Locational Net Benefit Analysis Working Group - Group I Interim Status Report

Prepared for the LNBA Working Group by More Than Smart on August 31, 2017

IOU Response Comments

Figure 1 – Image from SEIA Smart inverter Presentation

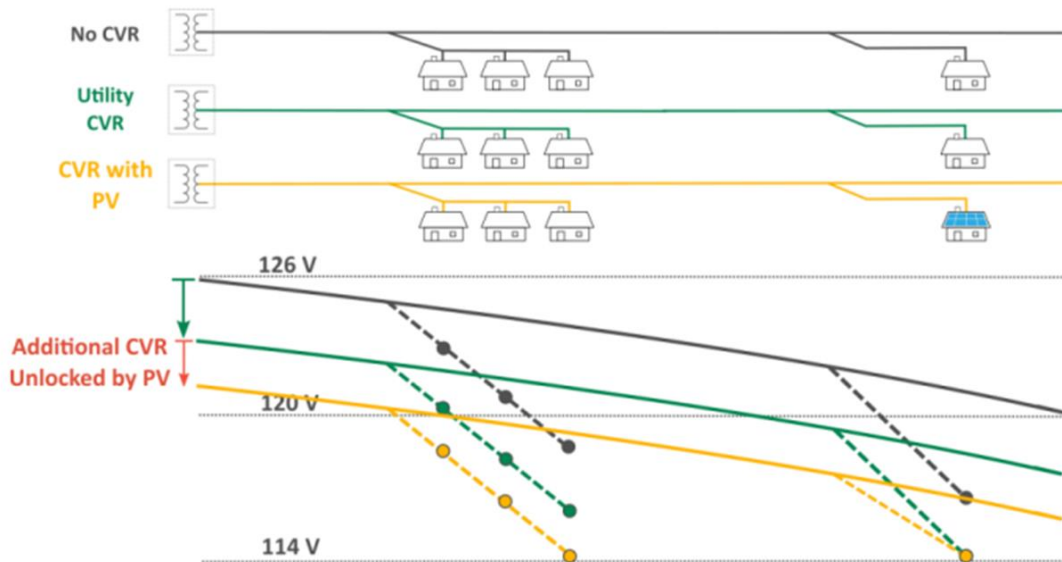
Specifically, this diagram (Figure 1) does not take account for customers downstream of the house with the ability to raise voltage at their location. In reality (Figure 2), if customers exist downstream of the same feeder, on unsupported bifurcated mainline, or on other feeders served out of the same substation without smart inverter functionality, these are at risk of being served high or low voltage.

Figure 2 – Customer without Smart Inverter Function Located at EOL Served Low Voltage

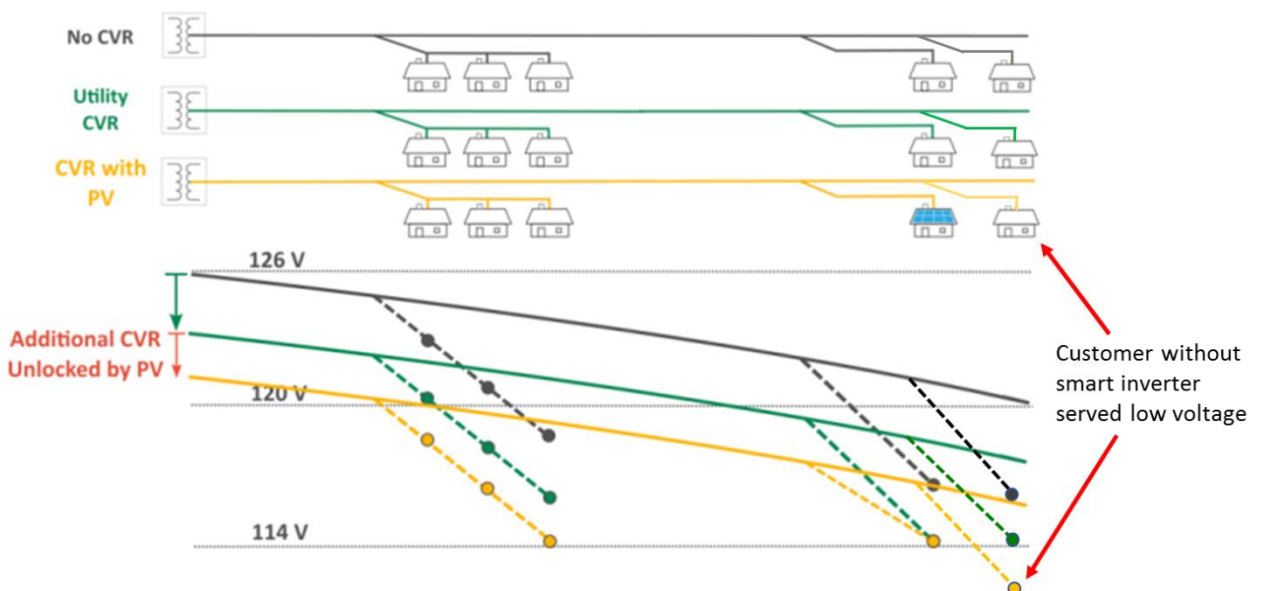
To implement CVR without the risk of serving low voltage to customers, all feeders connected to a substation need to be integrated in the CVR scheme and analyzed for voltage and loading impacts. Similarly, smart inverters would need to be strategically placed and programmed on all the feeders based on equipment and feeder characteristics to potentially achieve CVR benefits without detrimentally impacting customer voltage.
